Flood Consequences Assessment Addendum

Project	Five Fords, Wrexham, Wales
Project Number	23380

Date 28 August 2020

TITLE Proposed Alternative Site Layout			
SCALE 1:2500		PROJECT No. 23380	
REPORT TYPE DS		DRG. No. 02

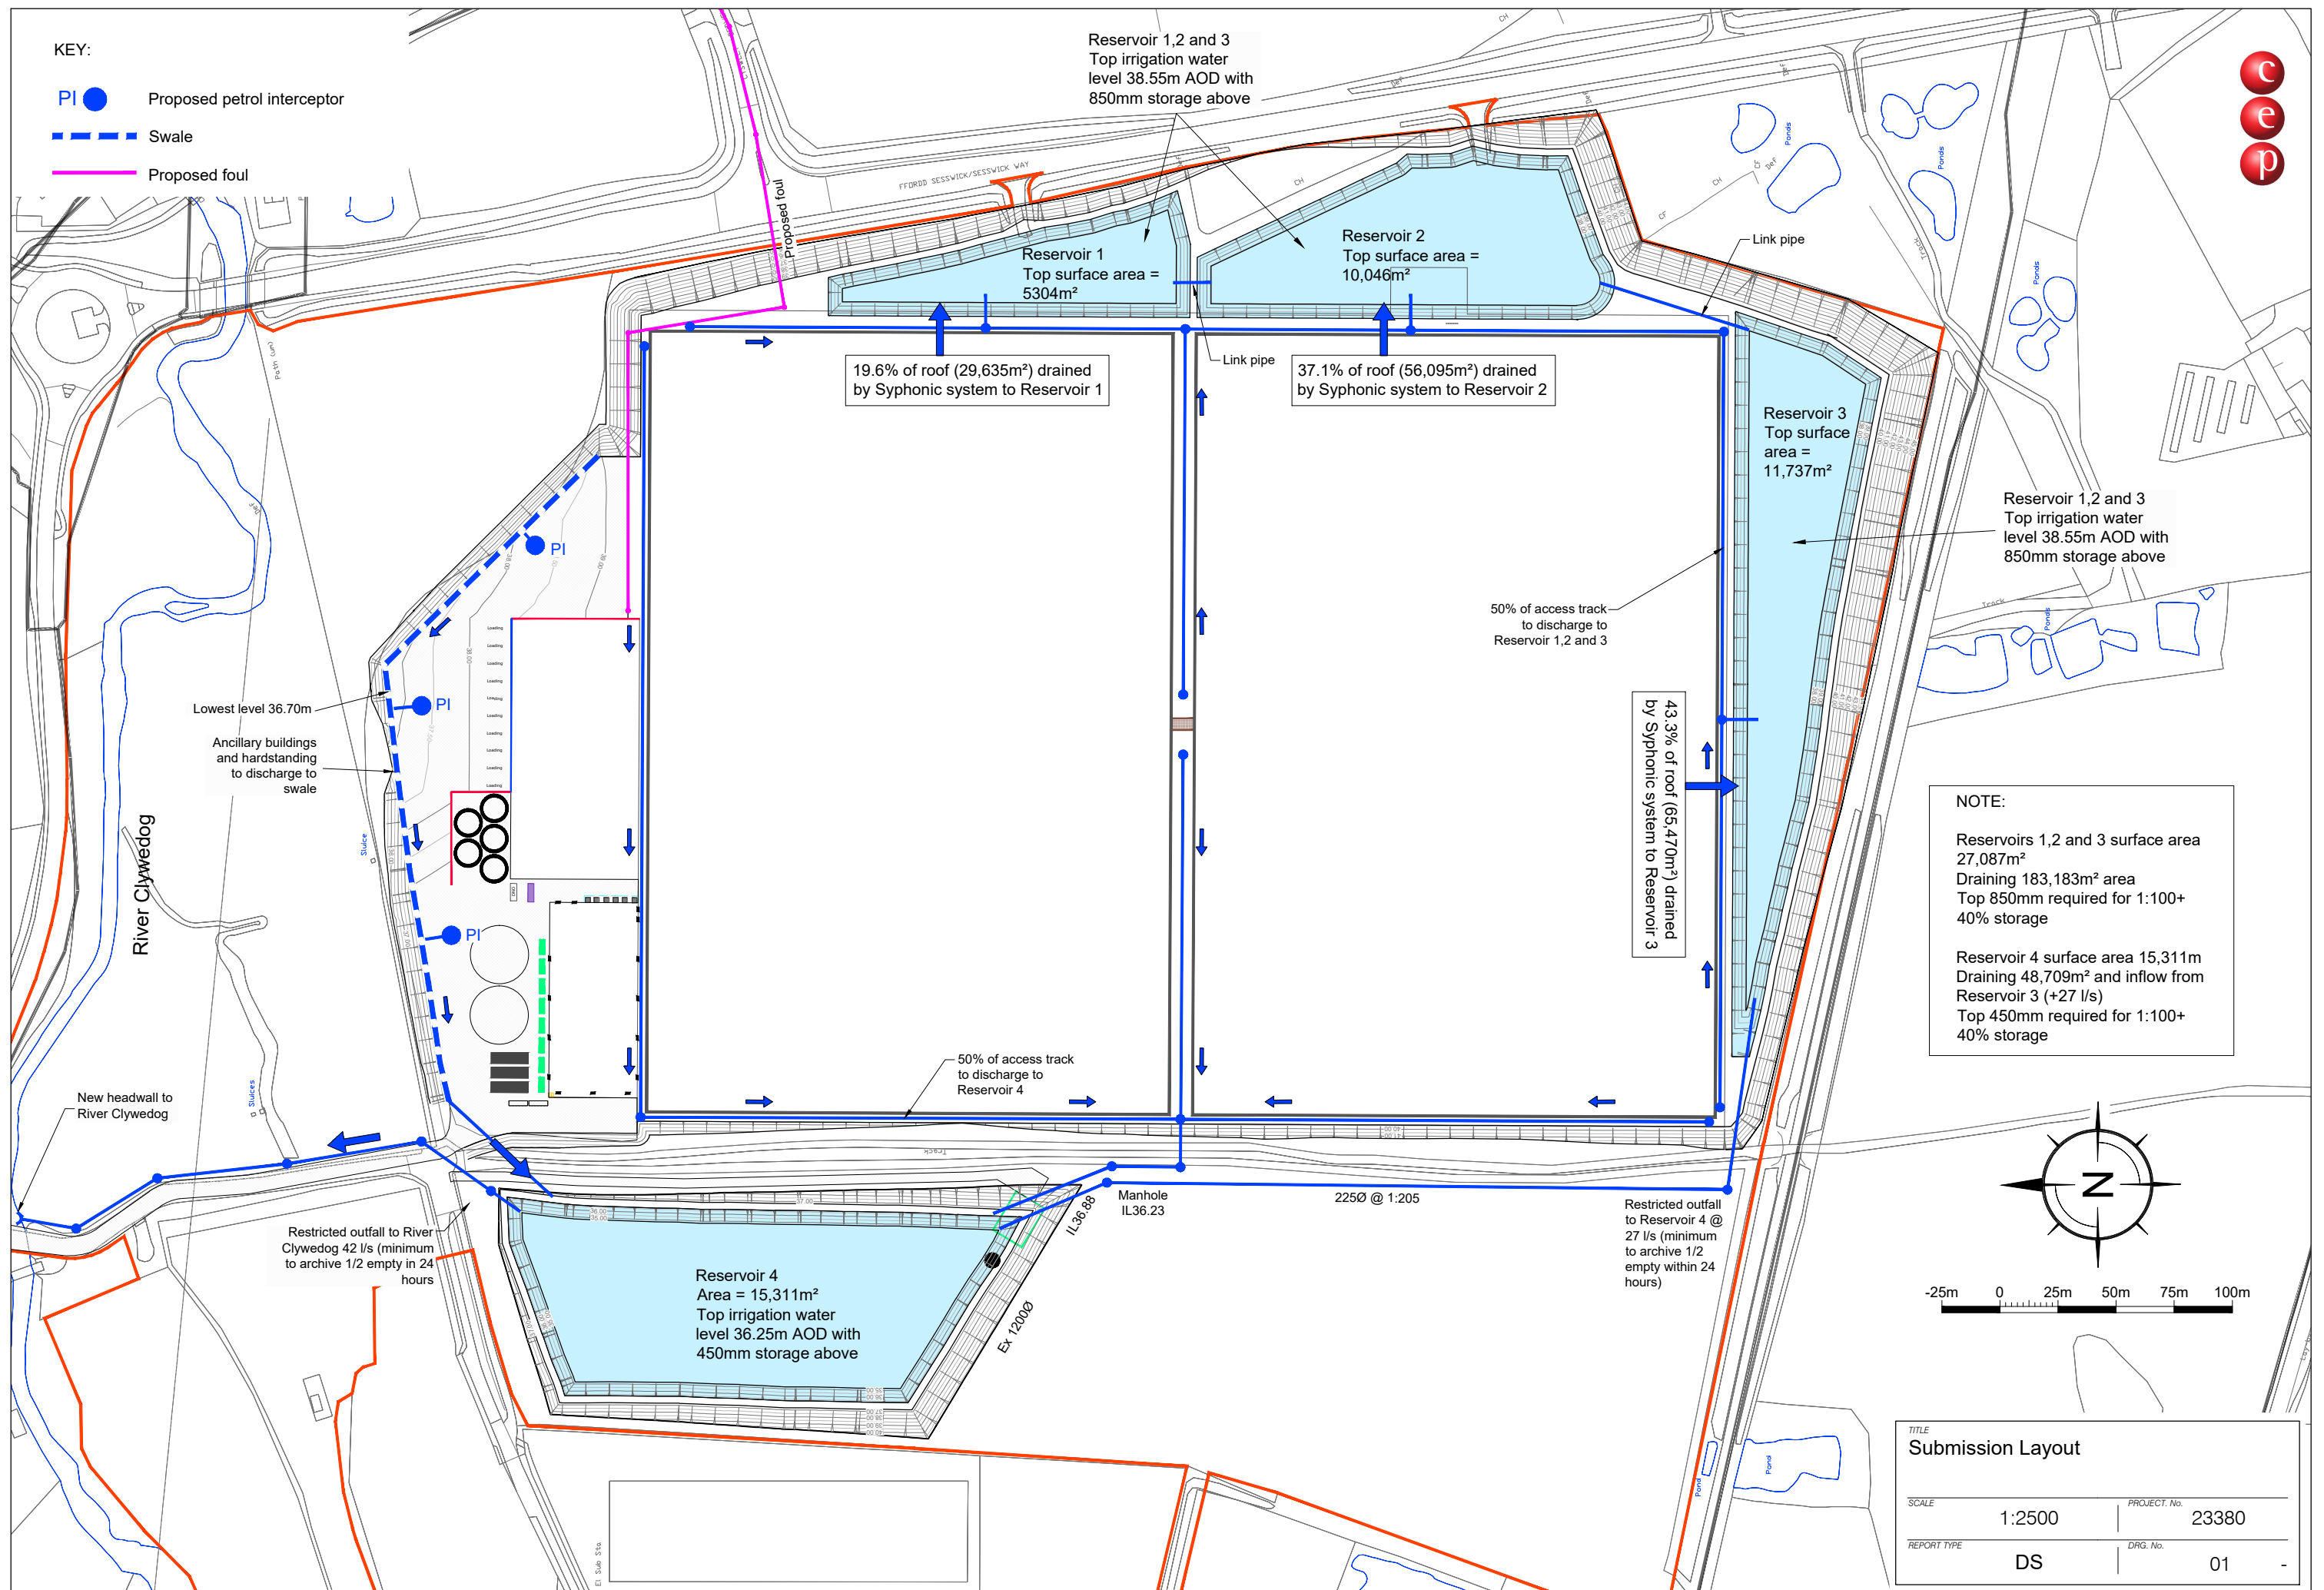
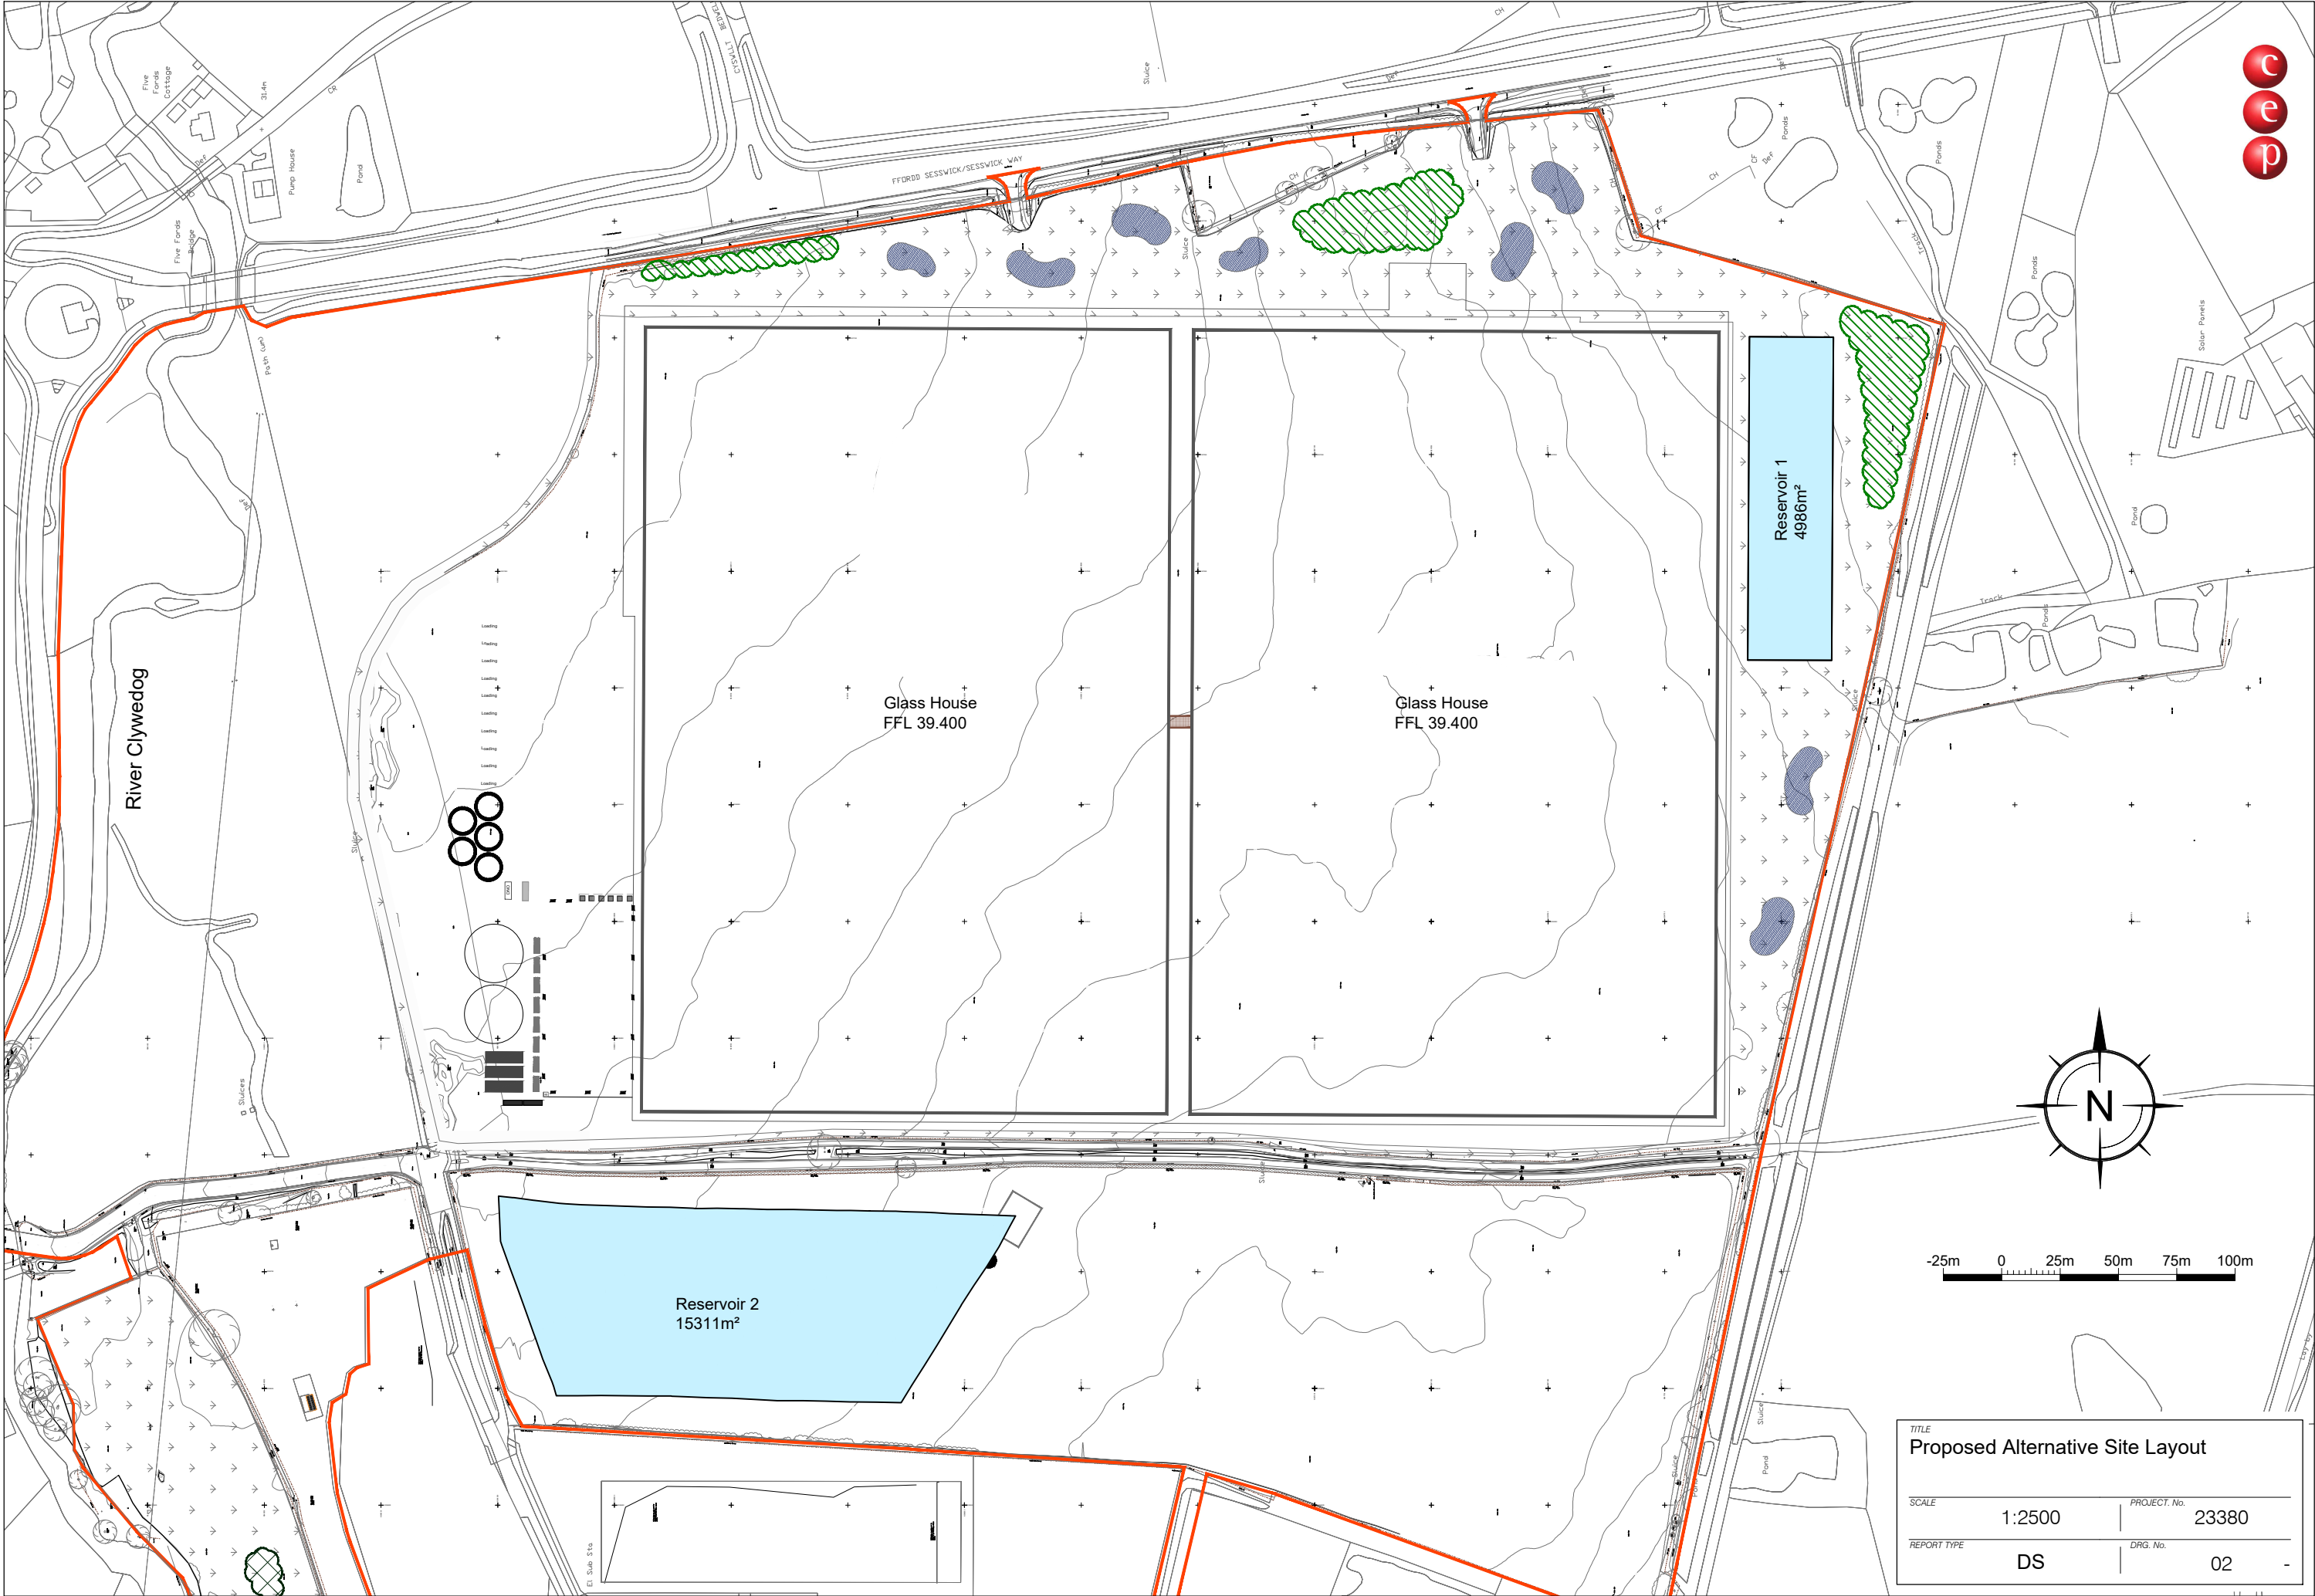
- 2.1 As a result of the identification of great crested newt habitat on the site the proposed location of the irrigation reservoirs has been altered so as to provide enhance habitat for the newts and also provide the required irrigation and storm water storage volumes on a like for like basis to the planning submission proposals.
- 2.2 The submitted plans include four reservoirs as follows:

2.4 The revised plans include two reservoirs as follows:

• Reservoir 1	South of Glasshouse	Surface Area	4,986m ²
• Reservoir 2	Northwest of Glasshouse	Surface Area	15,311m ²
			20,297m²

2.5 The total impermeable area of the site including the reservoirs now proposed is 20.9ha, 90.5% of the previous proposals.

2.6 The surface area of the reservoirs now proposed is 48% of the previous proposals.

4.1 Due to the reduction of reservoir surface area the storm storage volume of 28,100m³ will decrease to 25,430m³

4.2 A comparison of the require storage volume in relation to the surface area of the reservoirs confirms that for the revised proposals the depth of storage required above the operational irrigation water levels is approximately 1.33m.

4.3 The bed level of the reservoirs can be altered accordingly to provide the irrigation requirement,
